- Least populated... 2 contributions
- Cryostat and tuner compatibility: Slava Yakovlev
  - conceptual layout of a module for Phase I, 800 MHz SLAC cavity
- Mechanical & thermal issues: PP
  - generic consideration on module design
- Conceptual design advanced with respect to material presented at previous meetings
  - but for a single cavity design
    - which is still “moving” and “conceptual”, far from fabrication stage
    - still couplers/tuners are not defined, substantial work needed
  - still far from being complete
  - definition of all ancillaries (couplers, tuner, ...) needed to finalize important details for module design (supporting, thermal mgt.)

Initial FNAL design

LHC-CC09, 3rd LHC Crab Cavity Workshop

Schematic of the LHC Crab Cavity cryostat. The outer diameter (900 mm) is constrained by the limited space between Helium vessel and cryogenic line. The length is 1150mm.

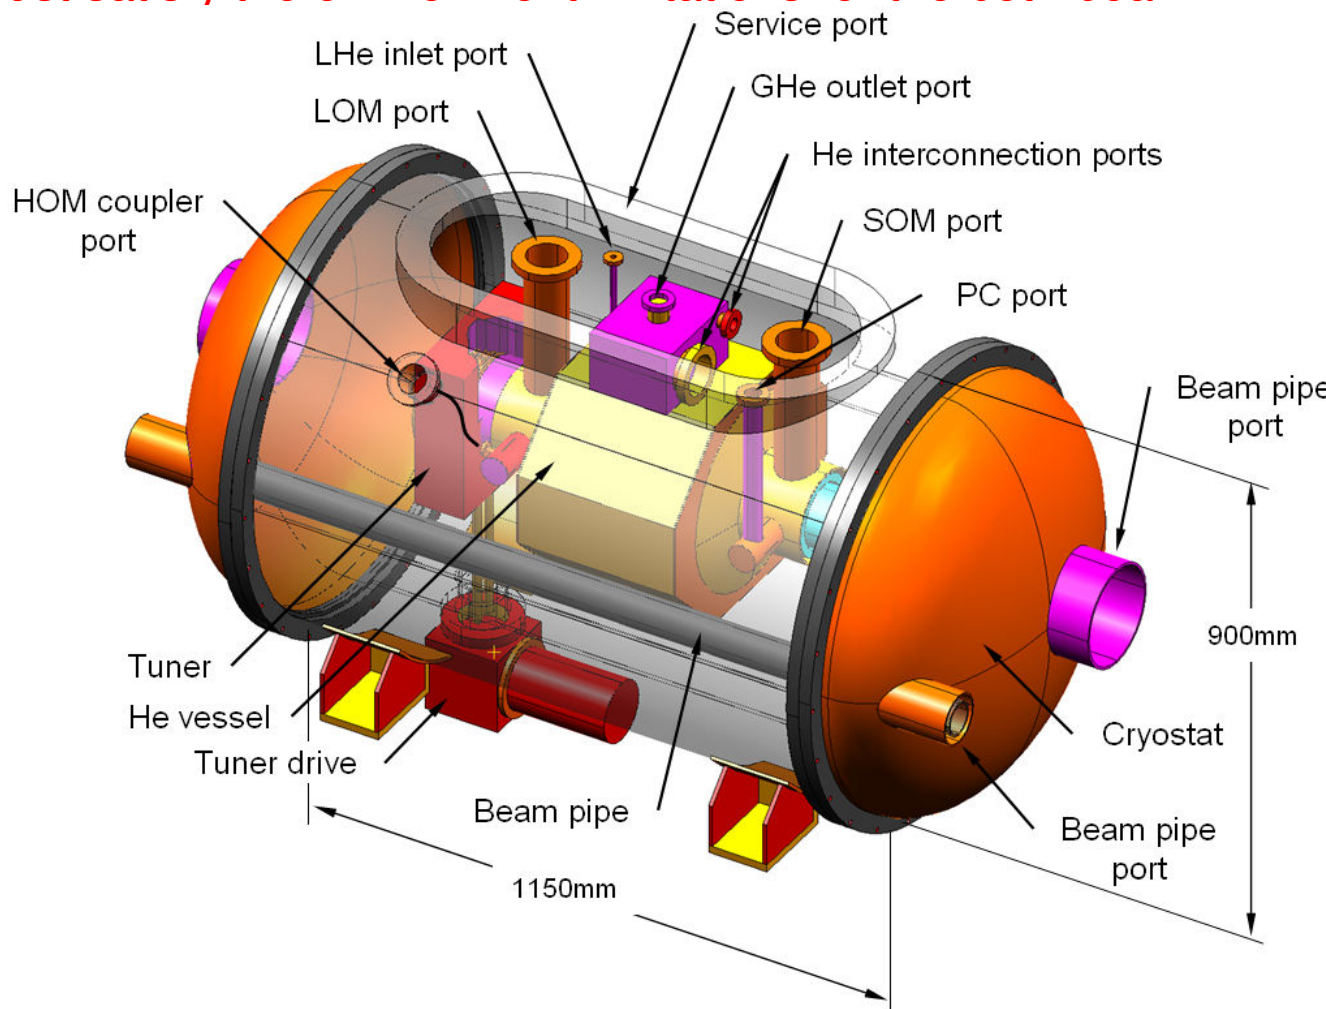
- Diameter of CM is  $\sim 900\text{mm}$
- **Very limited space** between Helium vessel and cryostat wall (QRL position vs. beam)
- No way for horizontal main coupler output (limits from both sides).
- Design of the main coupler with vertical output is required. Horizontal part of the coupler is limited ( $< 15\text{cm}$ )
- LOM and SOM couplers are already in vertical plane, HOM coupler is connected by cable
- Cavity position in the cryostat is asymmetric. It will probably **complicate alignment**, which is more severe than for accelerating cavity

concerns for the multiple couplers: mechanical and thermal issues

Realistic concept of the all the couplers is required for the complete cryostat design that includes:

- How to assemble
- Assembly tolerances
- Cooling scheme

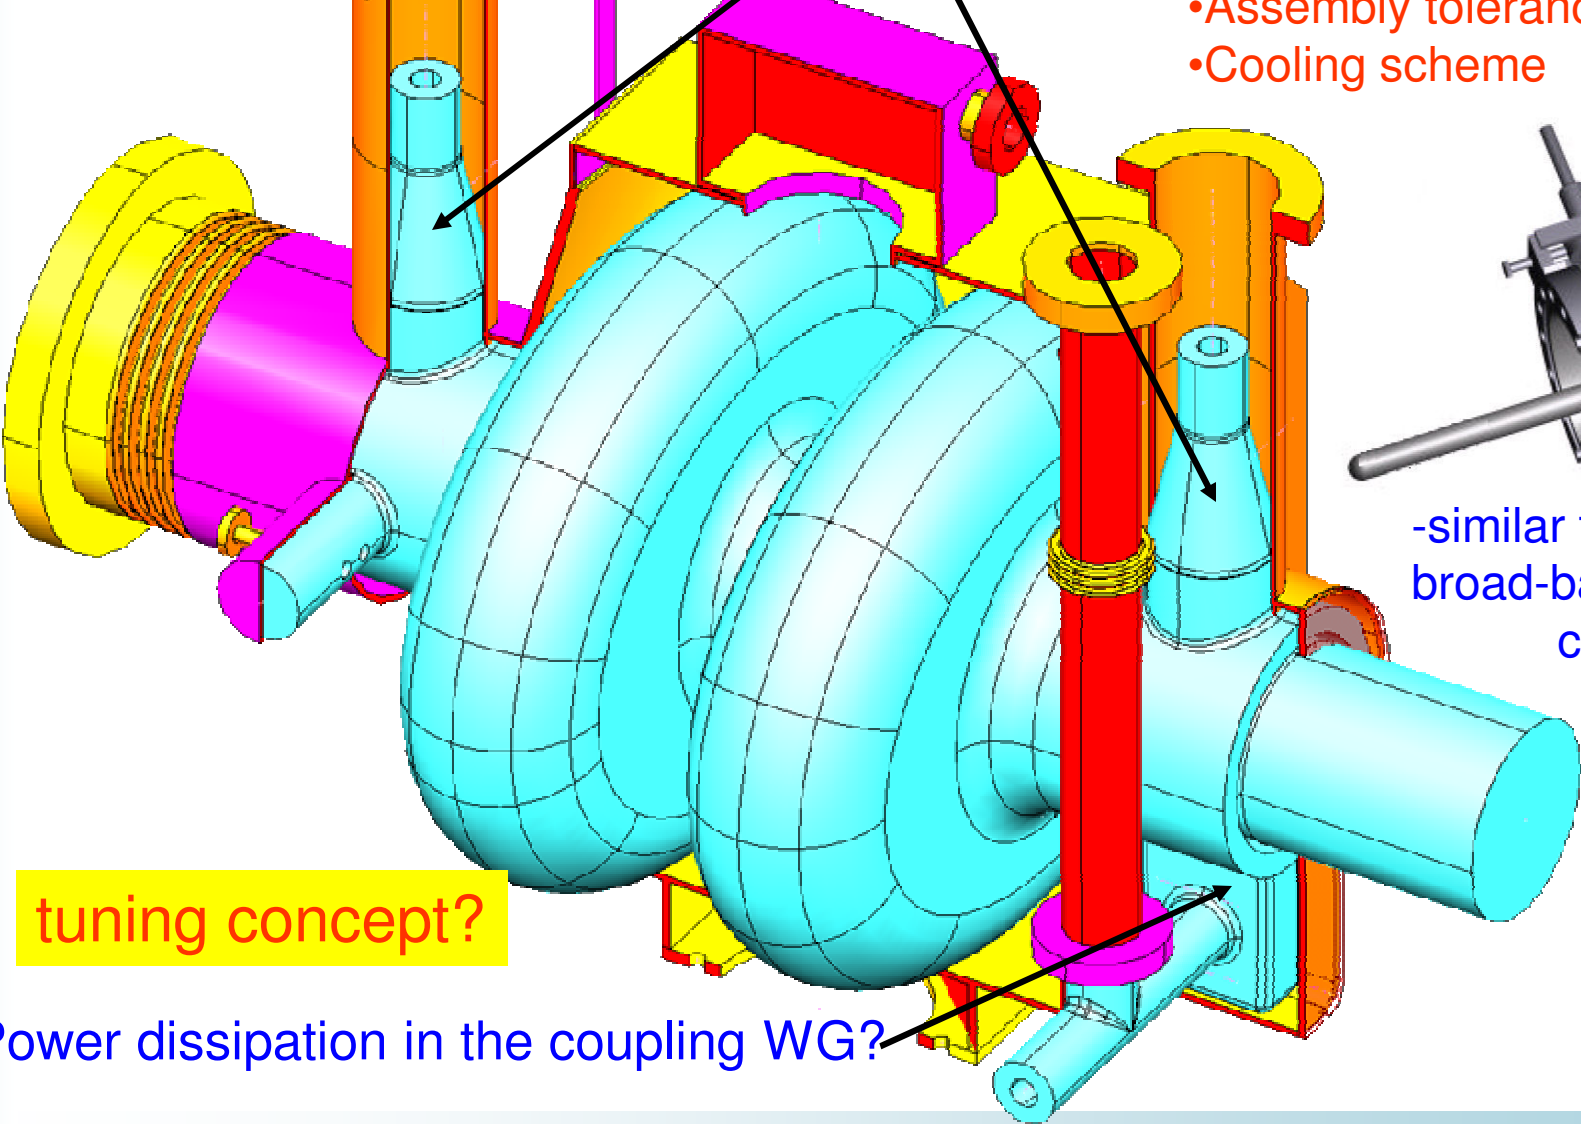
-similar to CERN broad-band HOM coupler.

tuning concept?

Power dissipation in the coupling WG?
